ELDORADO SPRINGS

STORM SEWER PLAN & PROFILES

ELDORADO SPRINGS	
STORM SEWER PLAN & PROFILES TITLE SHEET

Construction Drawings_v6 engr redlines.pdf Markup Summary

STORM SEWER PLAN & PROFILES
STM-PUB-01

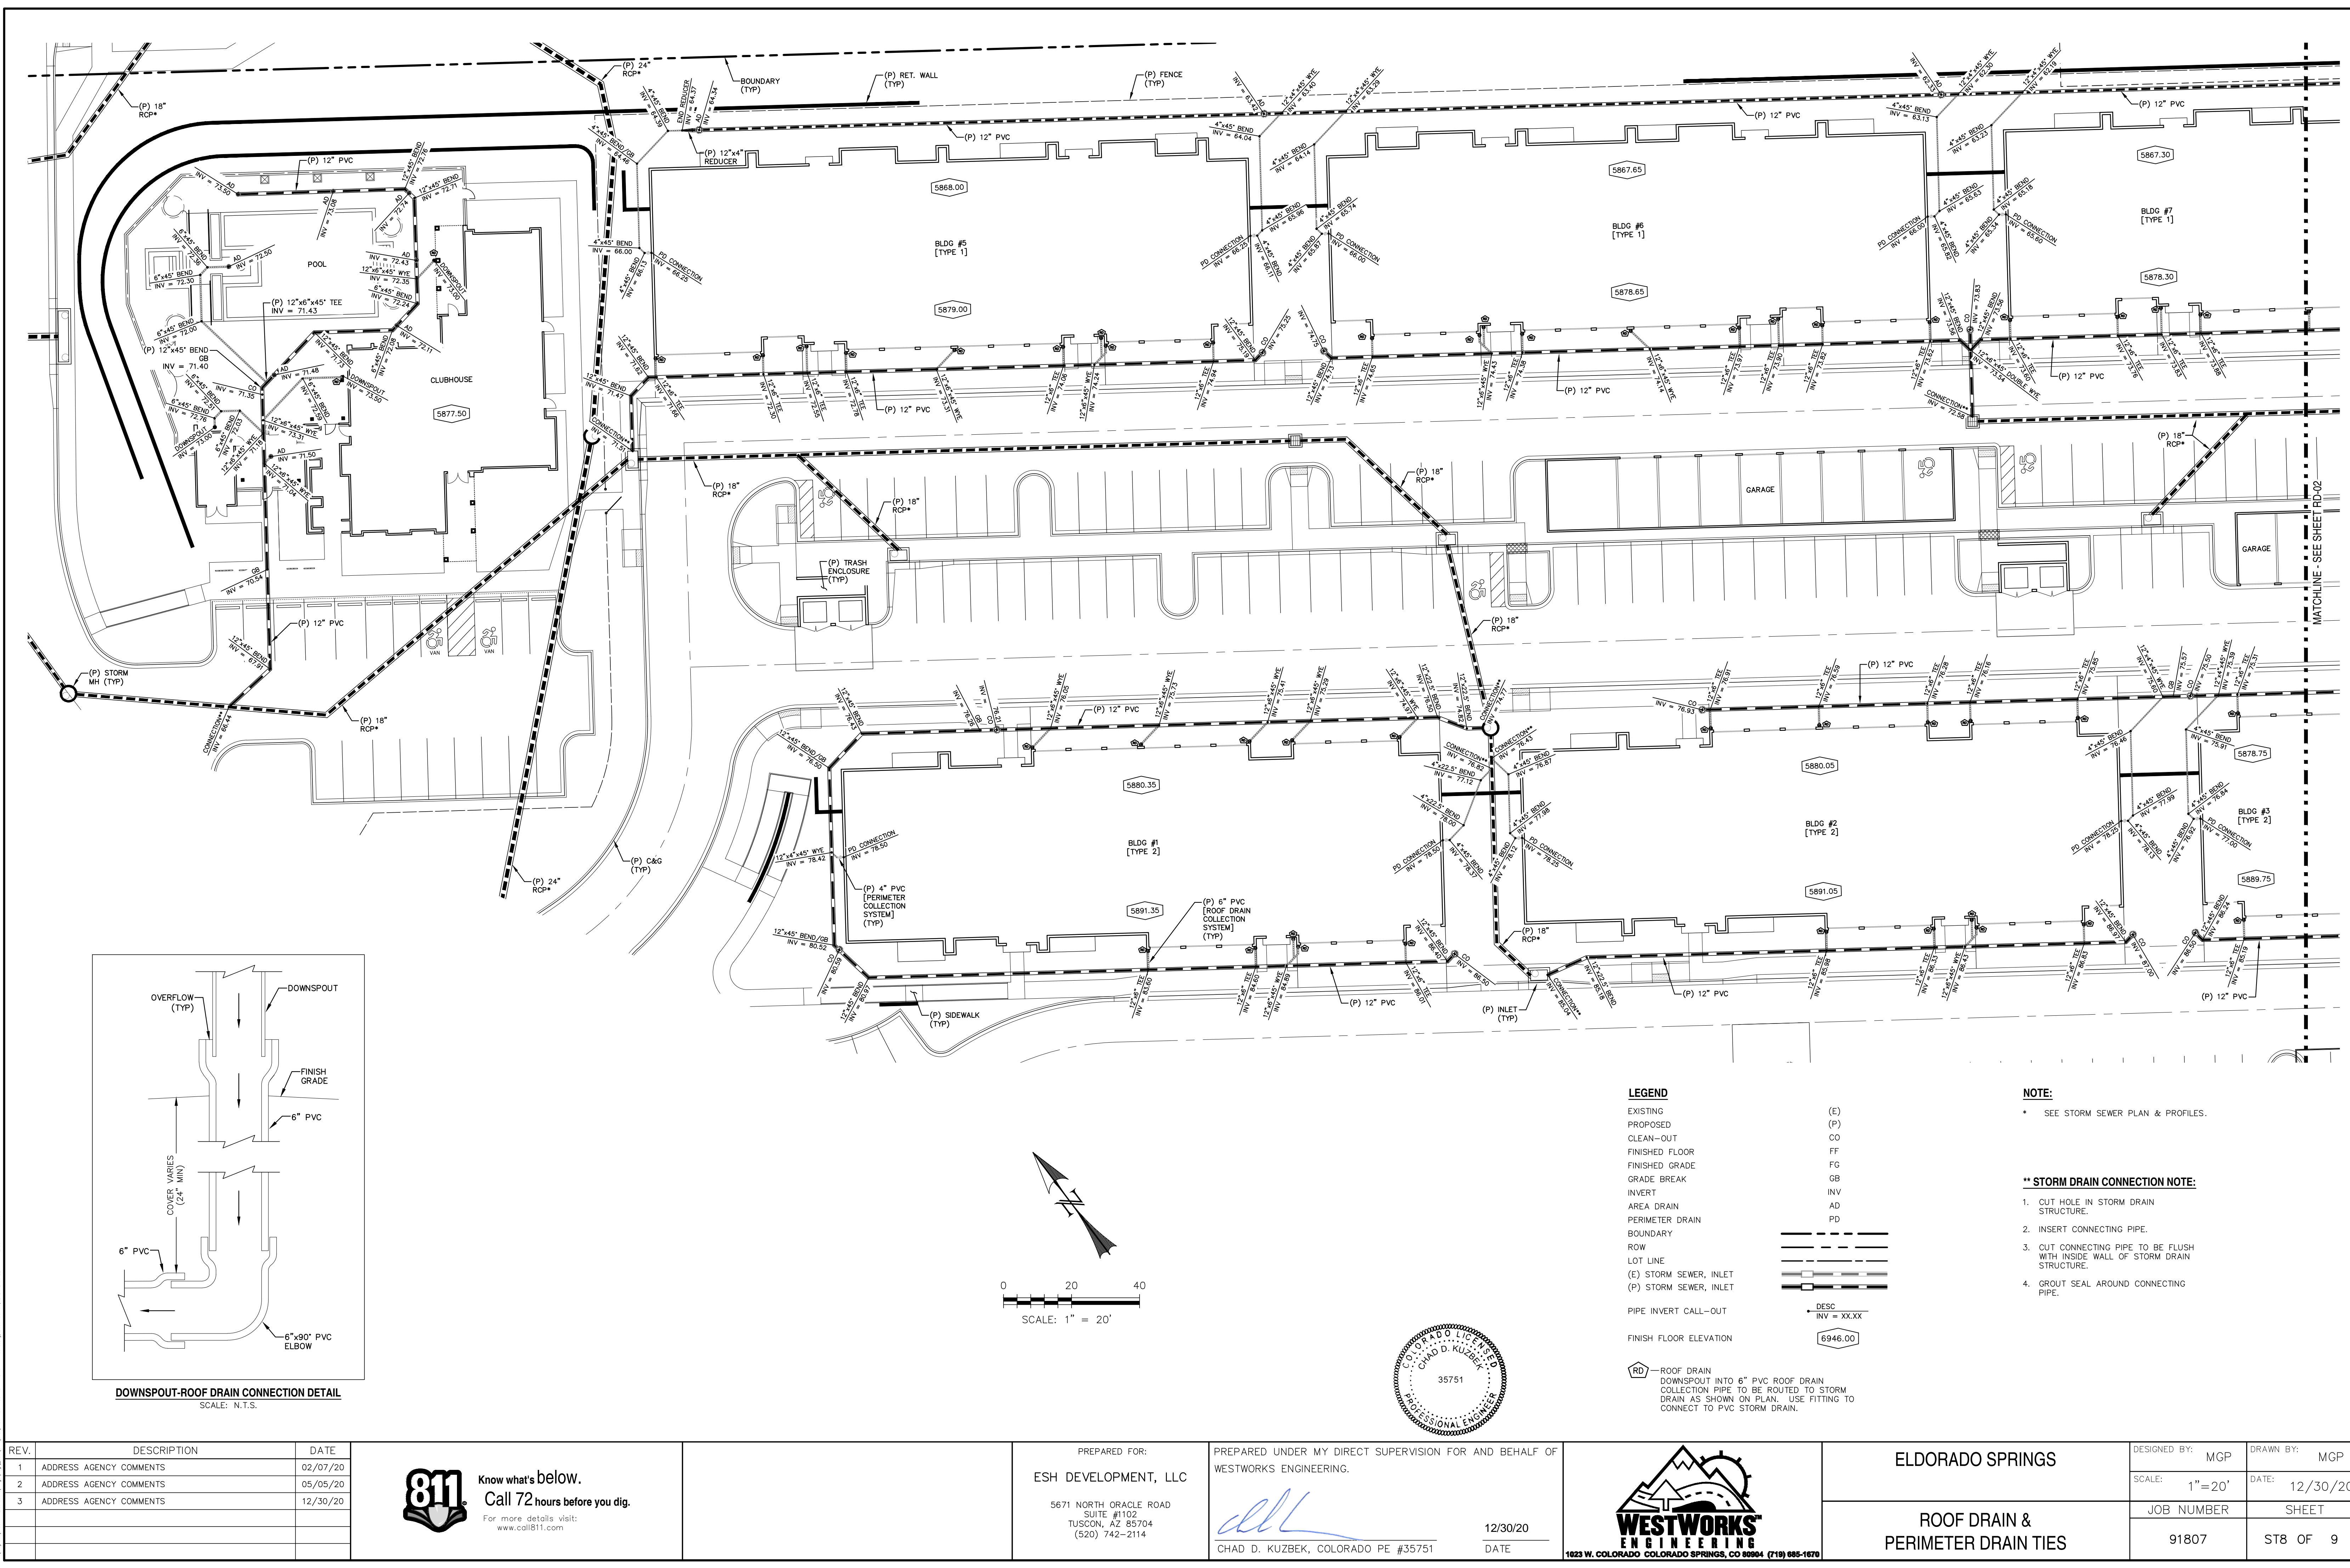
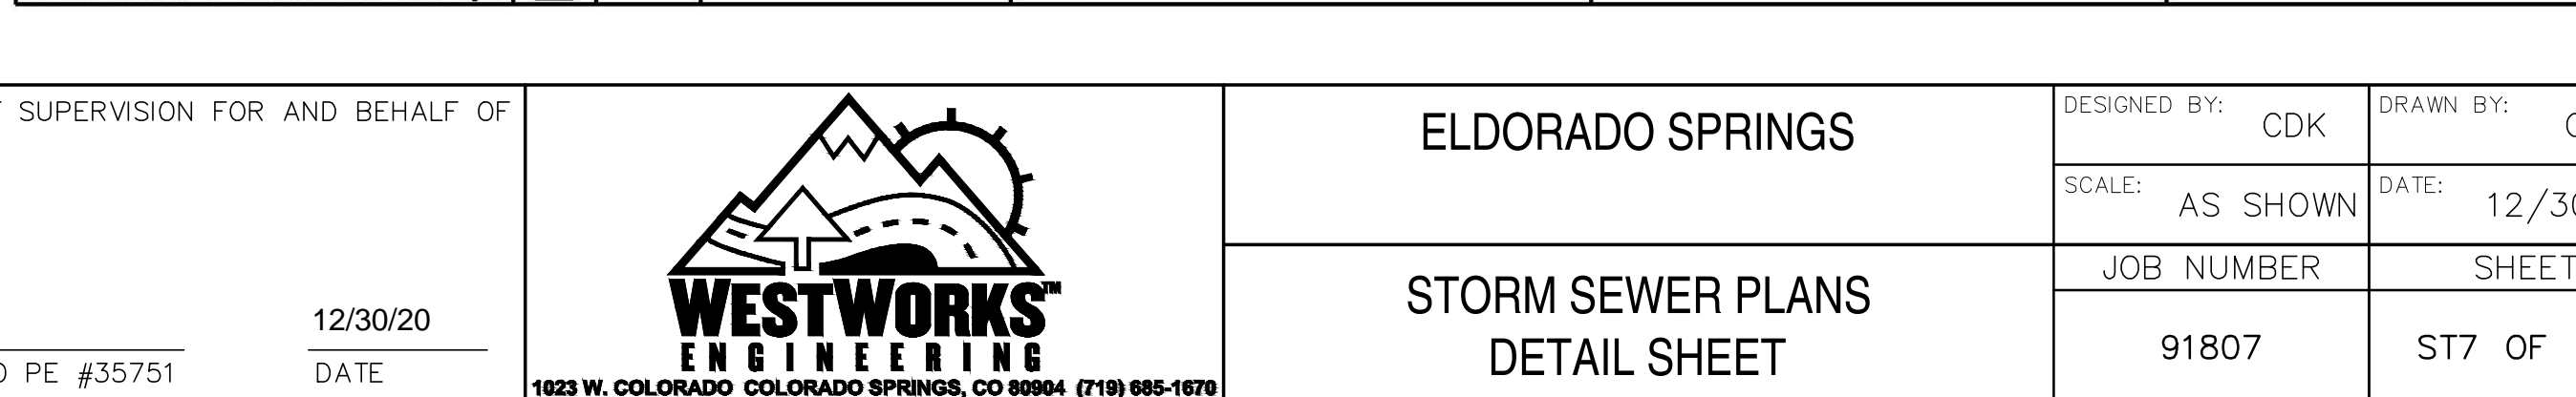
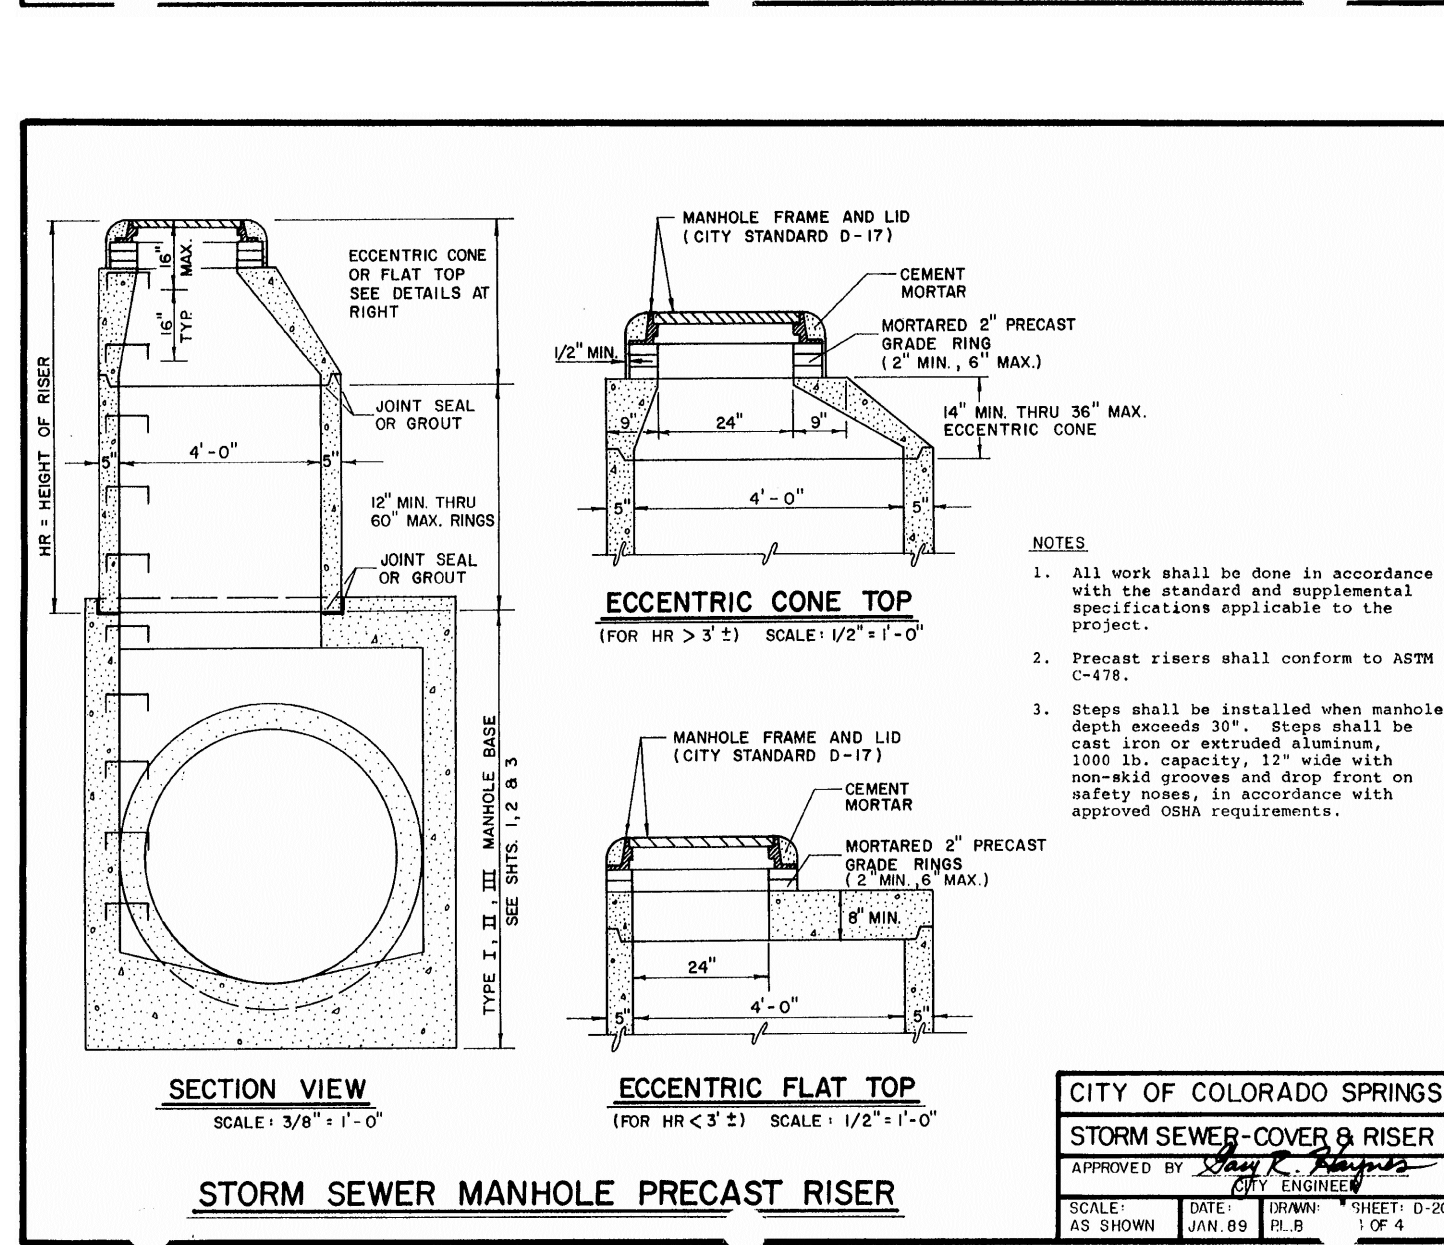
Per the review 5 comment letter, ST-L36 is approved through the City. Add a note referencing the specific approved City construction plan and note what's shown on this plan is for reference only.
